- 1. This Truss Placement Diagram is intended to serve as a guide for truss installation. This Diagram has been prepared by a Truss Technician and is not an engineered drawing.

> RESIDENTIAL ENGINEERING SERVICES, LLC SHOP DRAWING / SUBMITTAL REVIEW

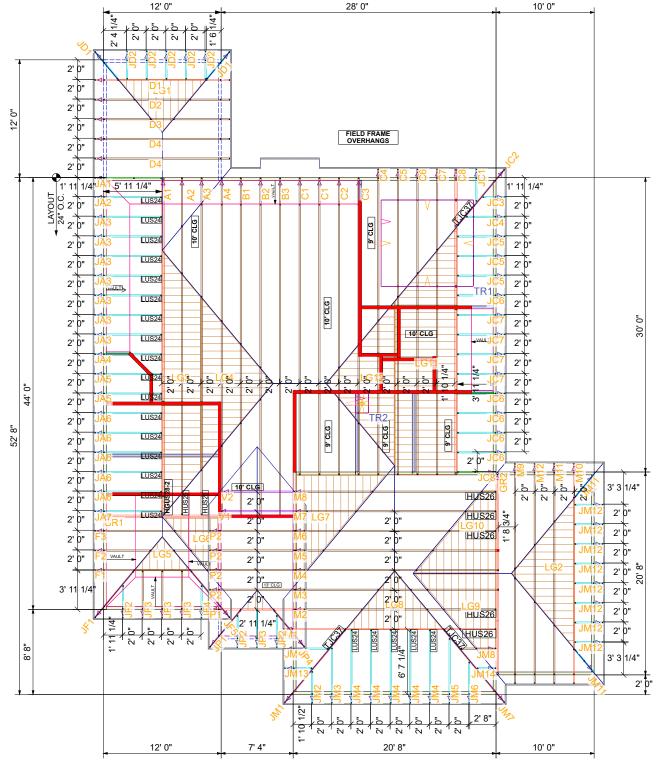
APPROVED

SUBMITTAL WAS REVIEWED FOR DESIGN CONFORMITY AND GENERAL CONFORMANCE TO CONTRACT DOCUMENTS ONLY. THE CONTRACTOR IS RESPONSIBLE FOR CONFIRING AND CORRELATING DIMENSIONS AT JOBSITE FOR TOLERANCE, CLEARANCE, QUANTITIES, **FABRICATION PROCESSES AND** TECHNIQUES OF CONSTRUCTION, COORDINATION OF HIS OR HER WORK WITH OTHER TRADES AND FULL COMPLIANCE WITH CONTRACT DOCUMENTS.
